Action ID: SAW-2005-21386

Subject: Modification to the 401 Water Quality Certification Pursuant to Section 401 of the Federal Clean Water Act for proposed Greensboro Eastern Loop from US 70 Relocation to SR 2303 (Lawndale Drive), Guilford County, Division 7. WBS Element No 34821.1.1, TIP Nos. U-2525B and U-2525C. NCDWR Project No. 20130918 ver.6.

**PERMIT DRAWING
SHEET 32 OF 93**

PERMIT DRAWINGS
SHEET 79 OF 93
REVISED 06/12/2015

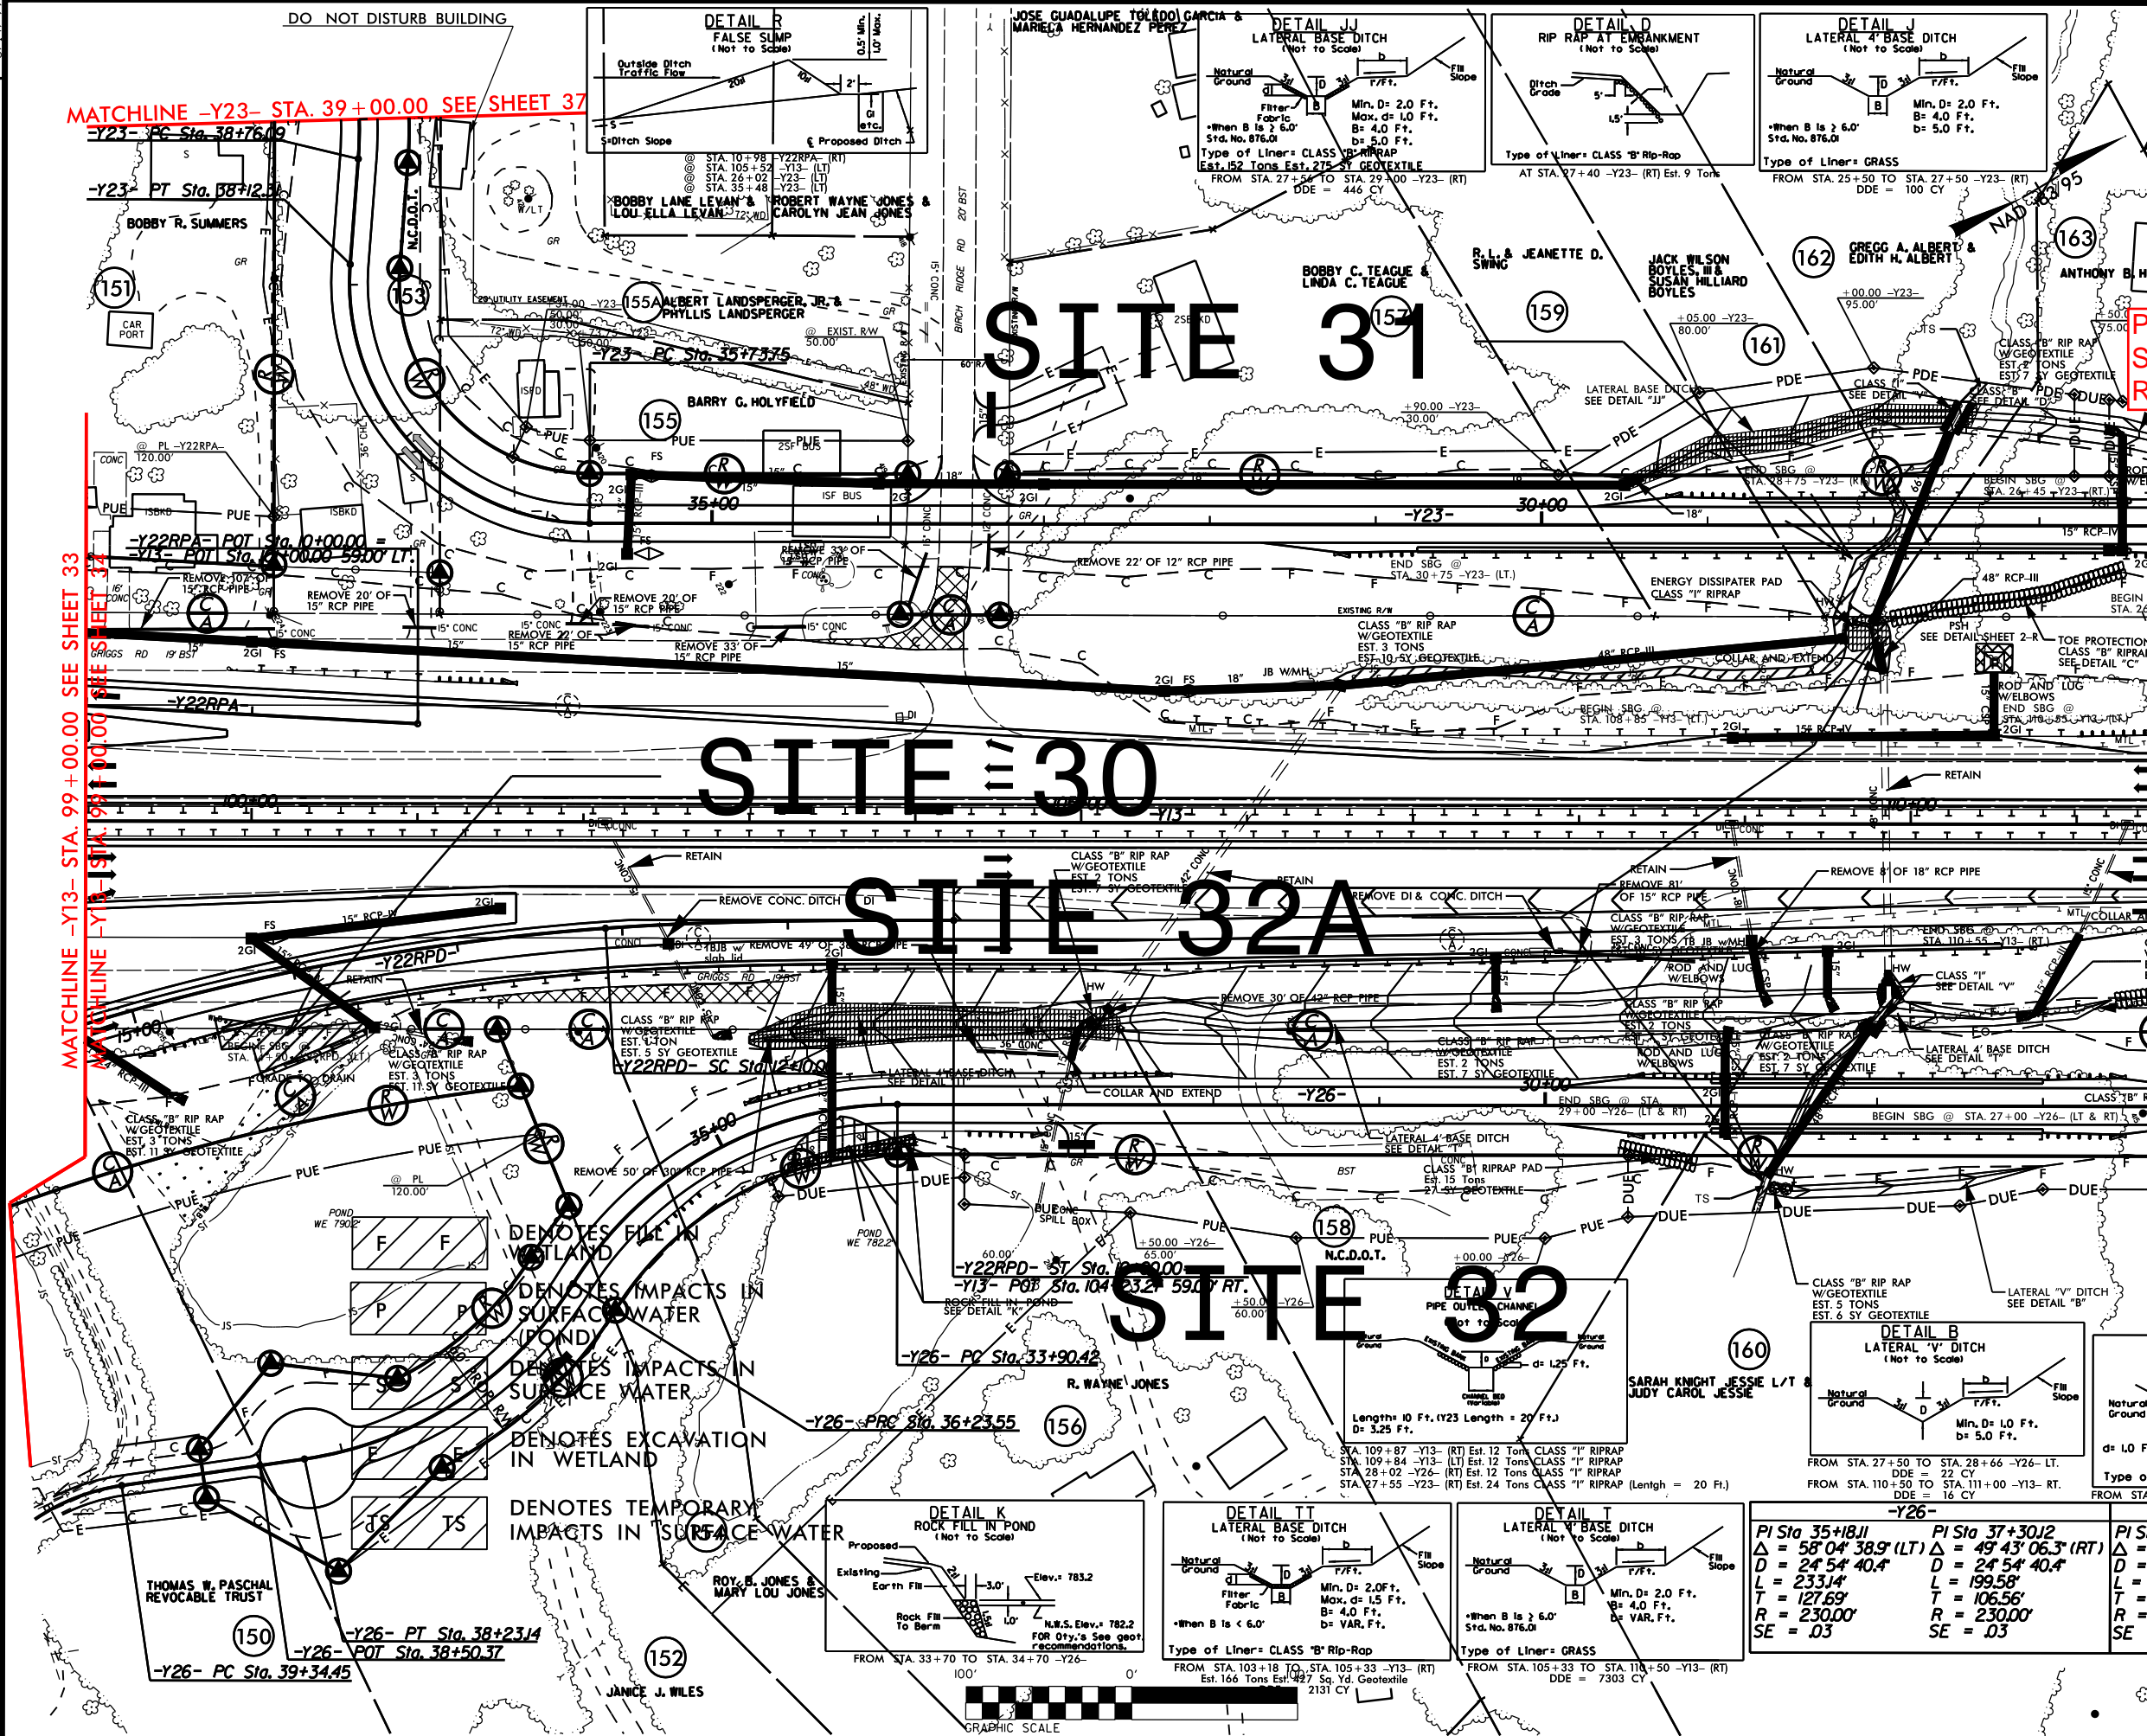
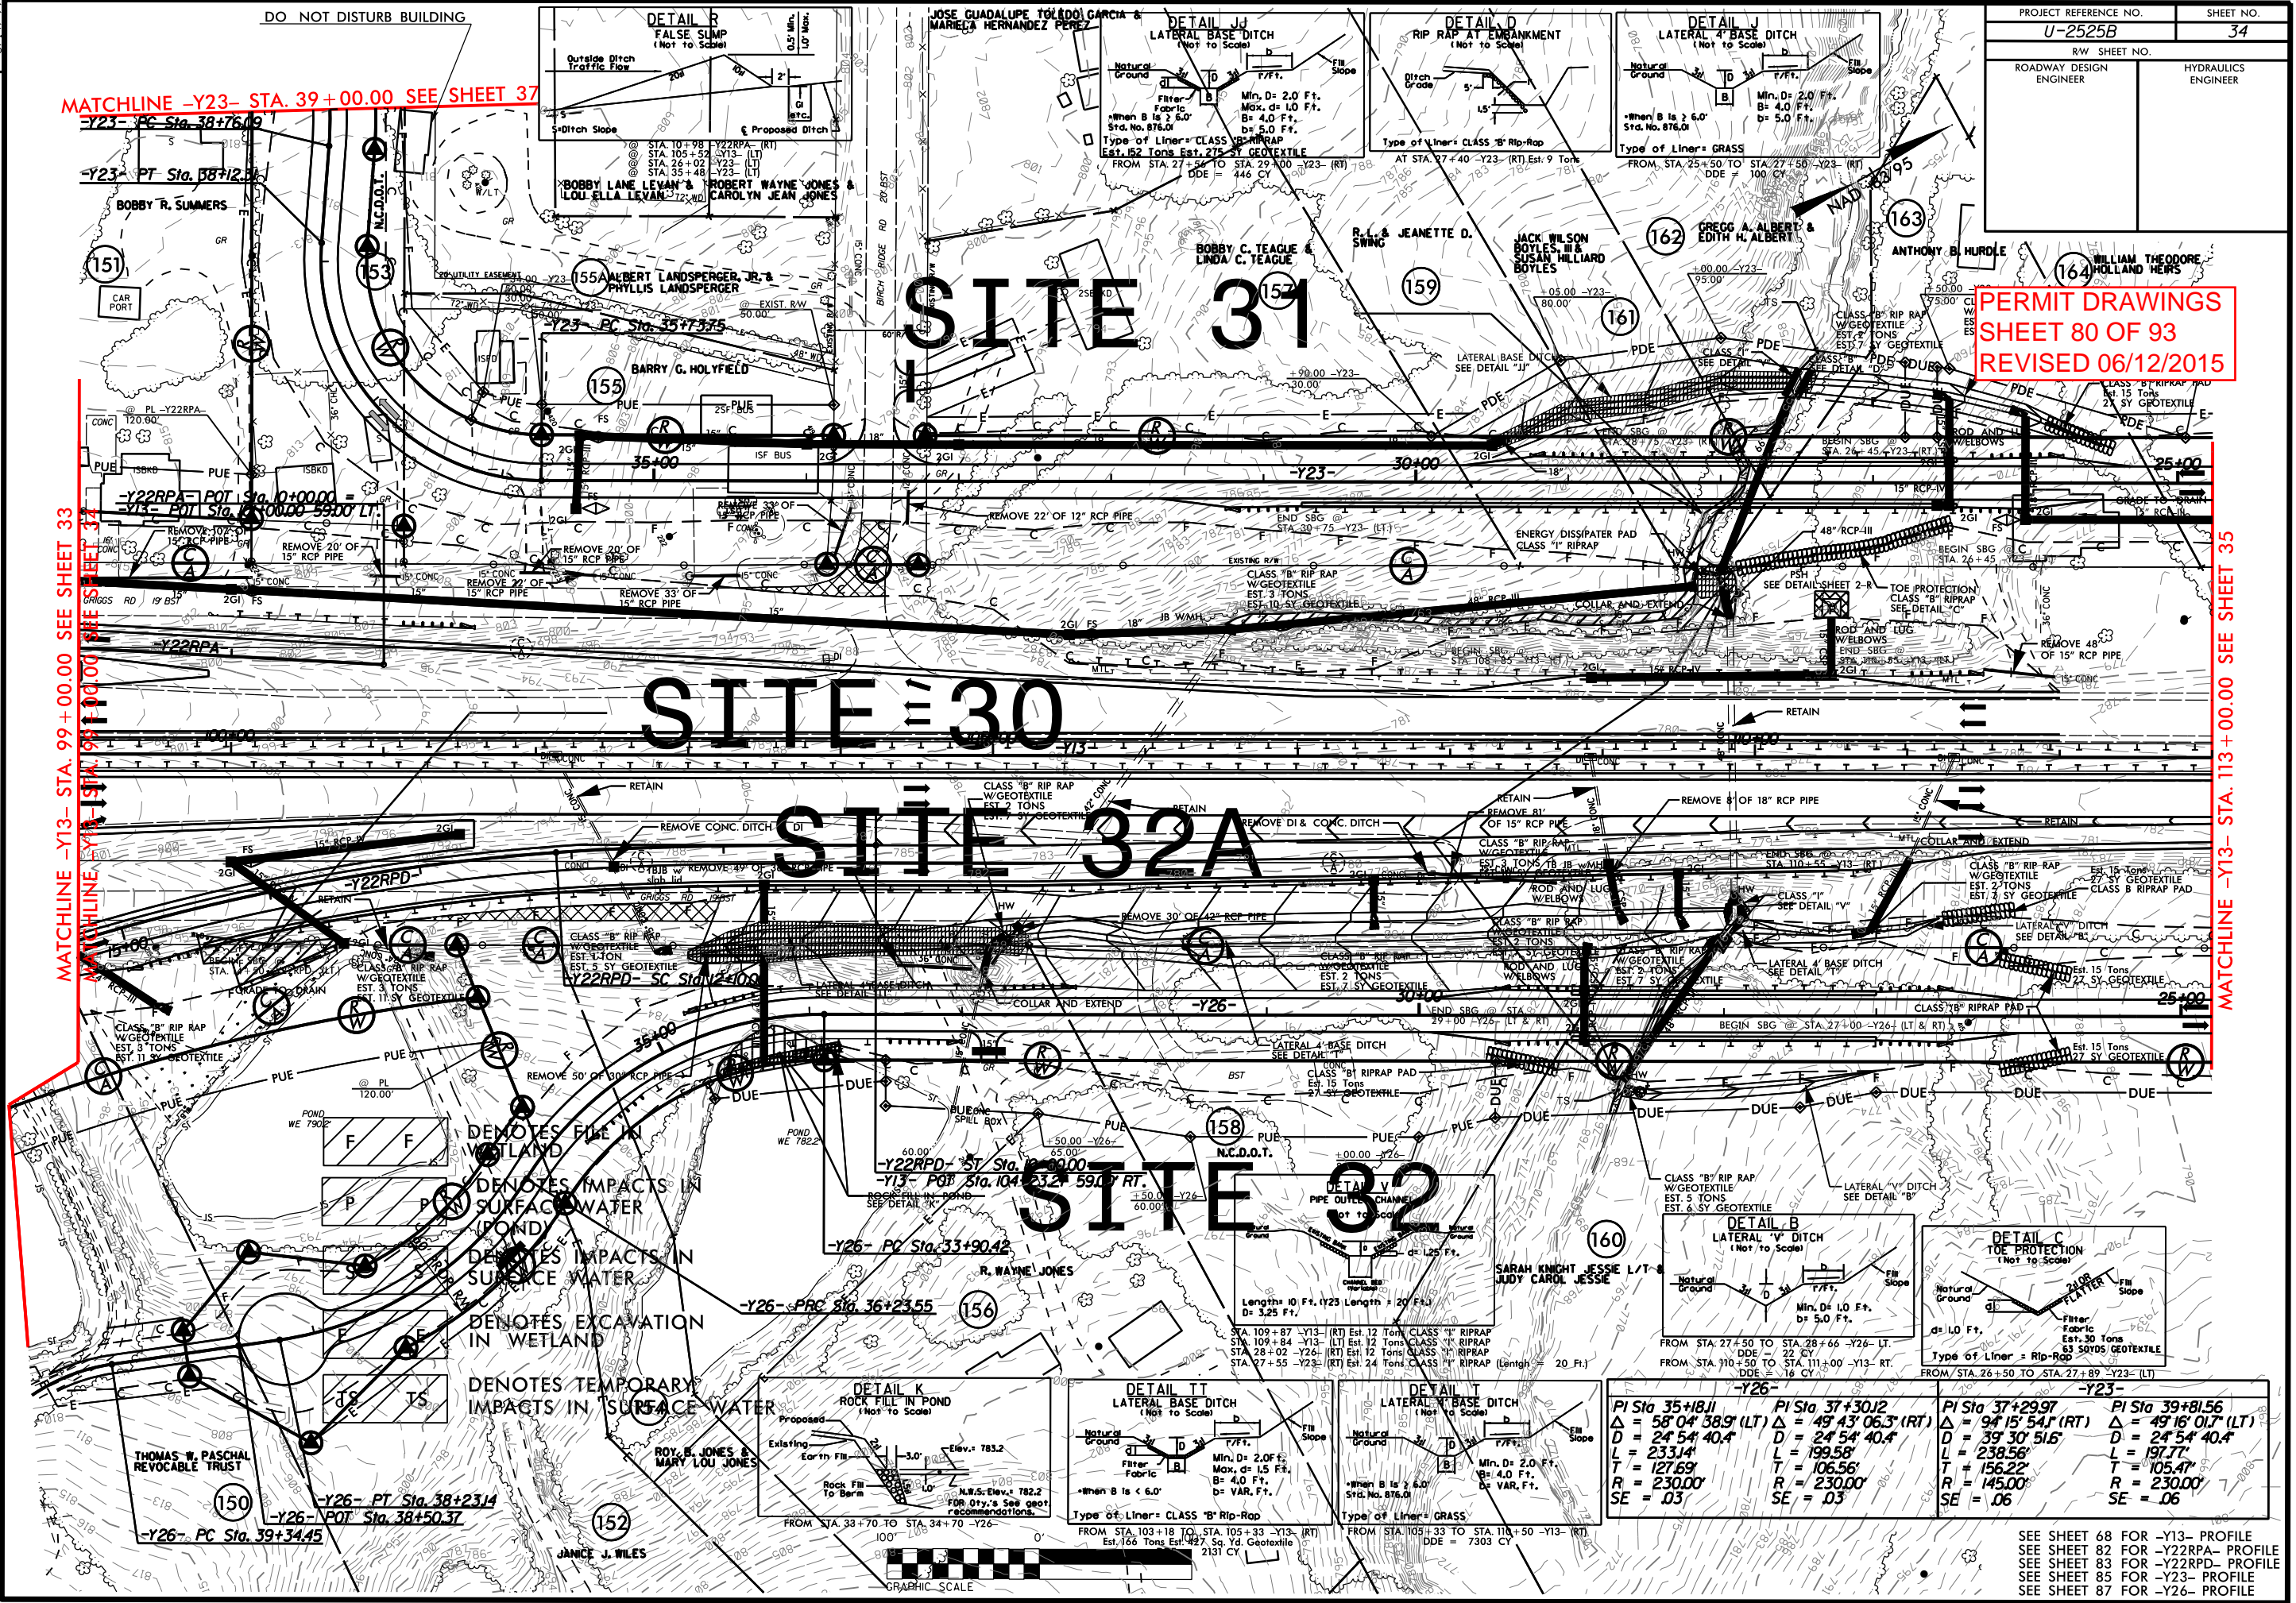
- 1) placing 286 linear feet of stream in a culvert (loss of waters) at Permit Site 31, due to safety and slope stability concerns related to widening and adding a travel lane to US 29;

- 2) placing 28 linear feet of stream (authorized as bank stabilization in the original permit) in a culvert (loss of waters) at Permit Site 32A to correct perching at the downstream end of an existing culvert;
